Project Address 4175 Iron Gate Road Zip Code 98226
Tax Assessor Parcel Number (s) 3803083362100000
Project Description The project includes construction of a new 94-lot subdivision with associated access roads and utility infrastructure.

Subject: Response to Request for Information  
Queen Mountain Plat – 4175 Irongate Road

Permit(s): SUB2022-0021; VAR2022-0007; CAP2022-0018, SEP2022-0024

SHEET CONTENTS:  
**WETLAND IMPACTS**

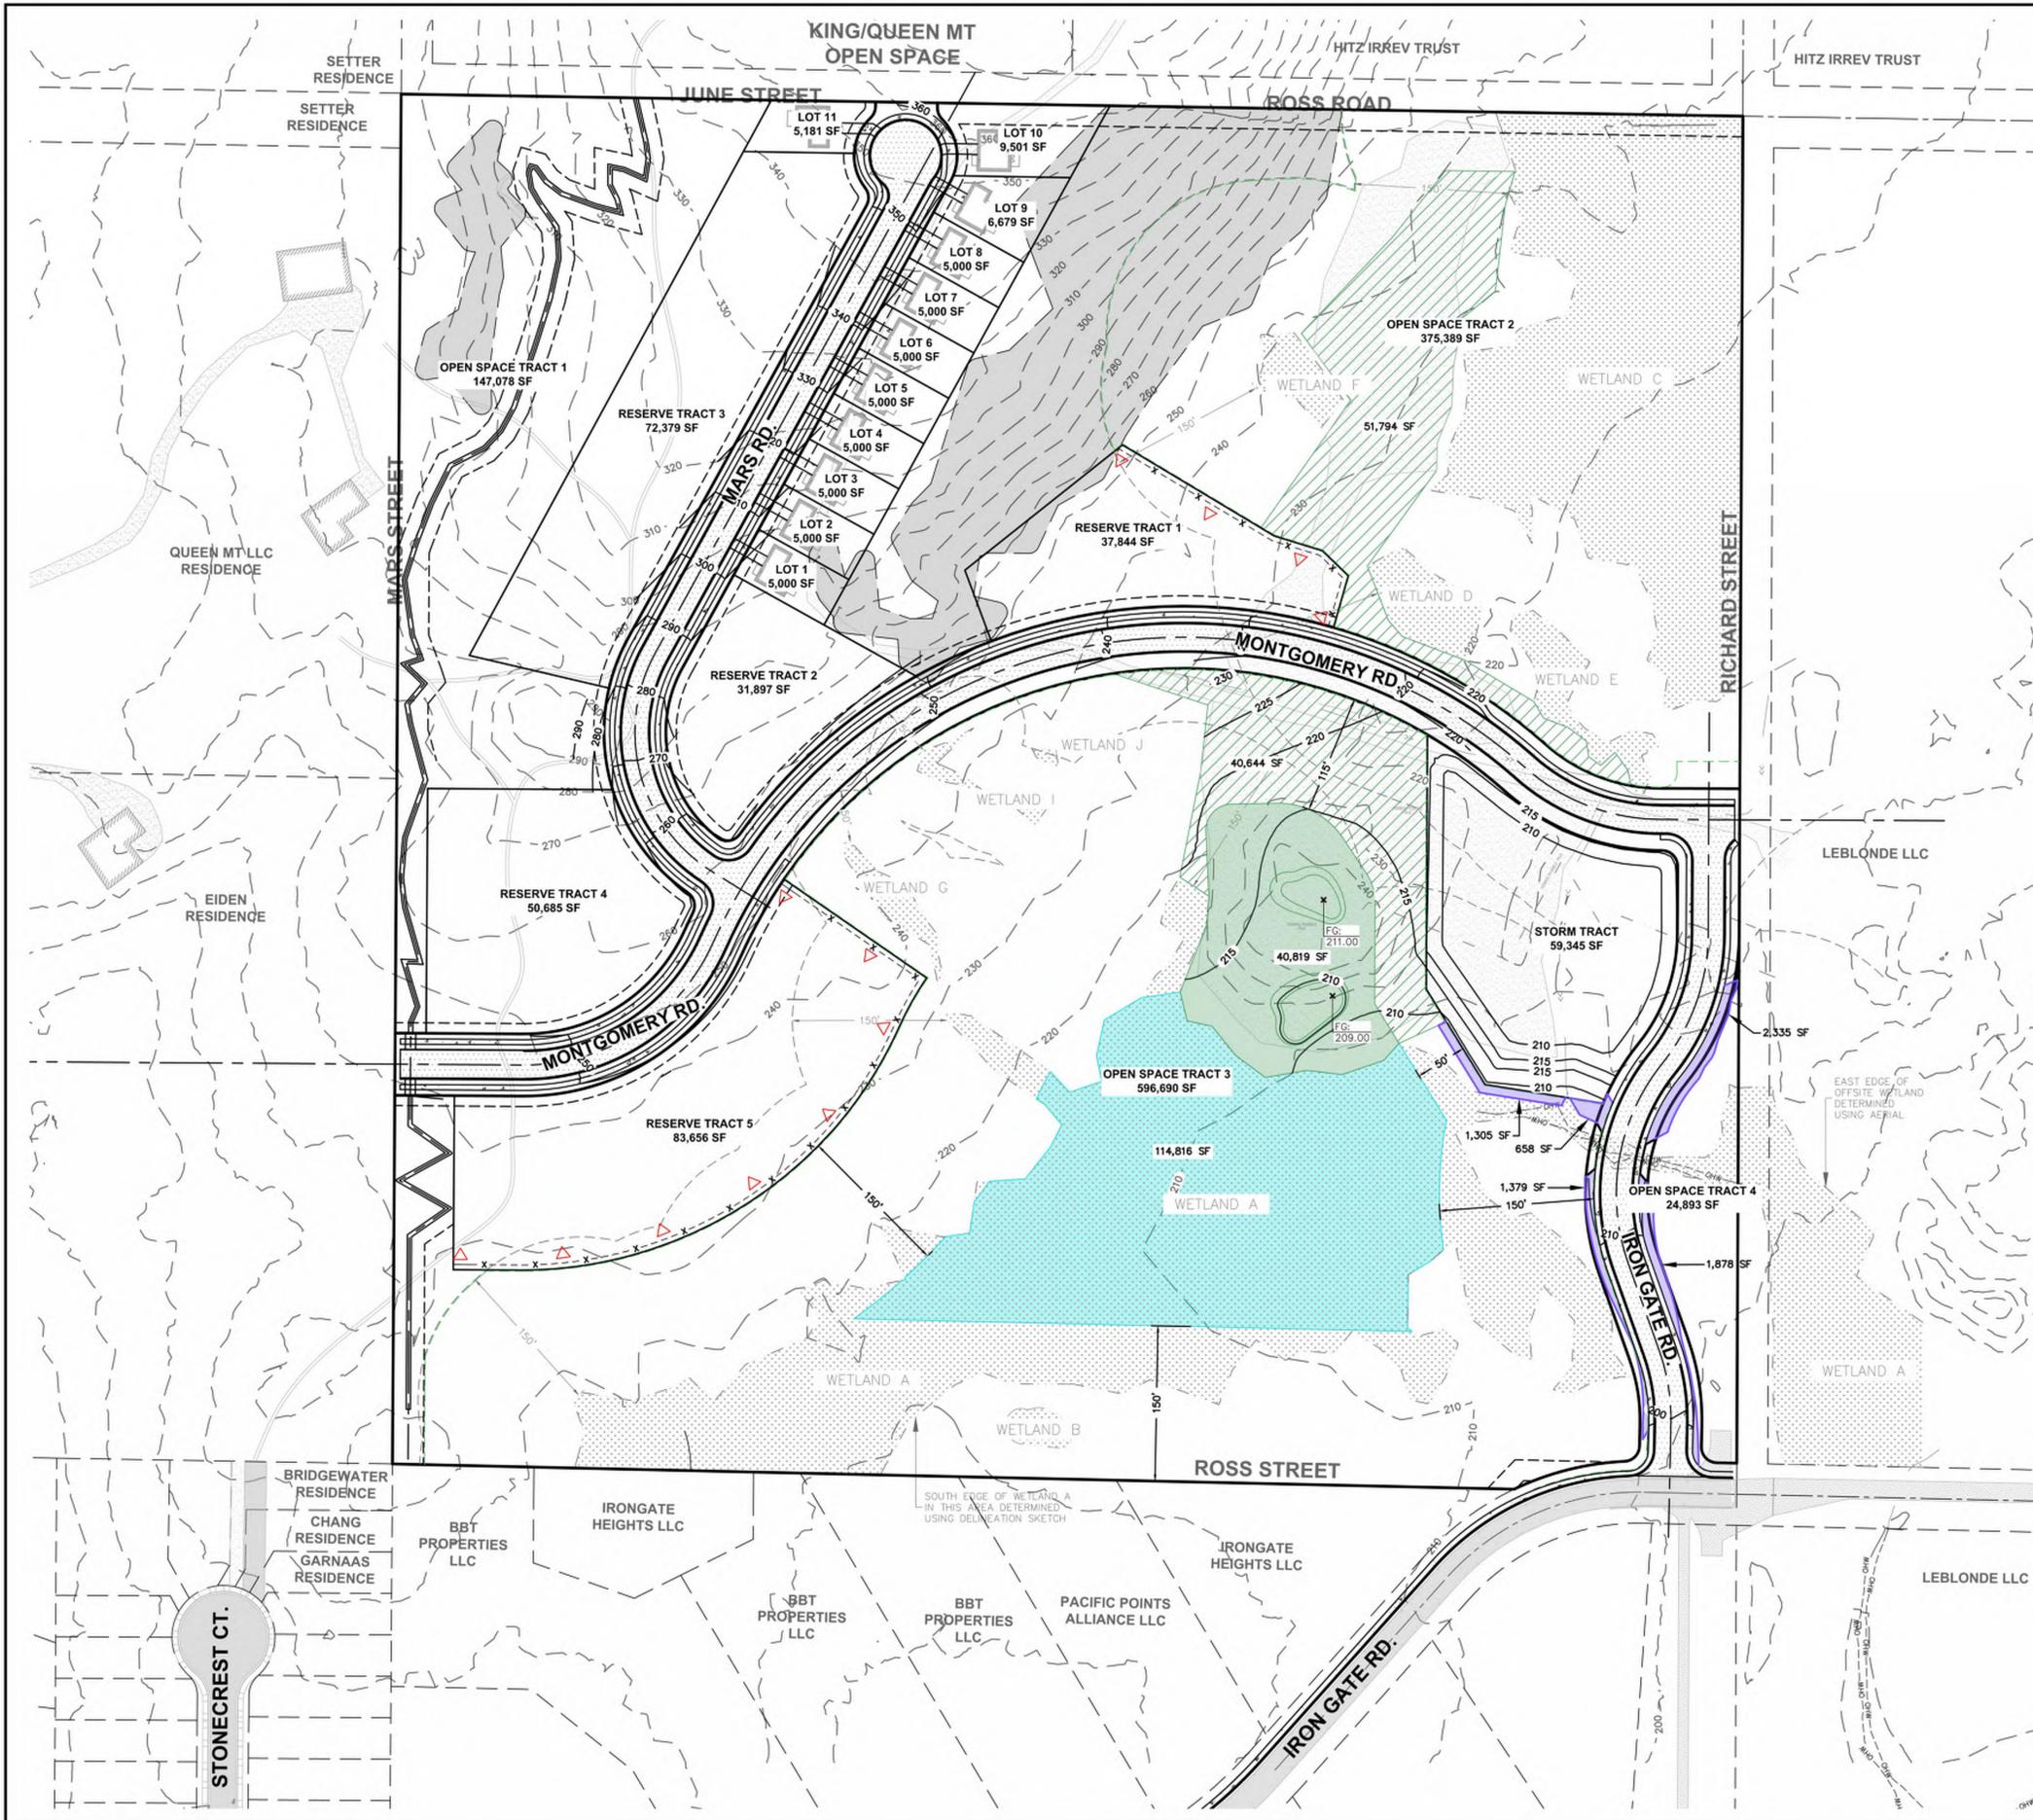
- It does not appear that impacts to wetlands D and E are accounted for as a result of the proposed stormwater facility. i.e., it appears there are indirect impacts proposed but are not tallied in the impact amounts on sheet W2 and in tables 2 and 3.

**Response: (Miller Environmental)** Since the prior submittal, the site plan has changed. The site access road has shifted northward. A small portion of Wetland E is tabulated as direct impact, while all remaining areas of Wetlands D and E are tabulated as indirect impact.

**This information is included in Section 6.1 of the updated Mitigation plan and summarized in Table 2. Impacts are shown on Sheet W2 in Appendix A.**
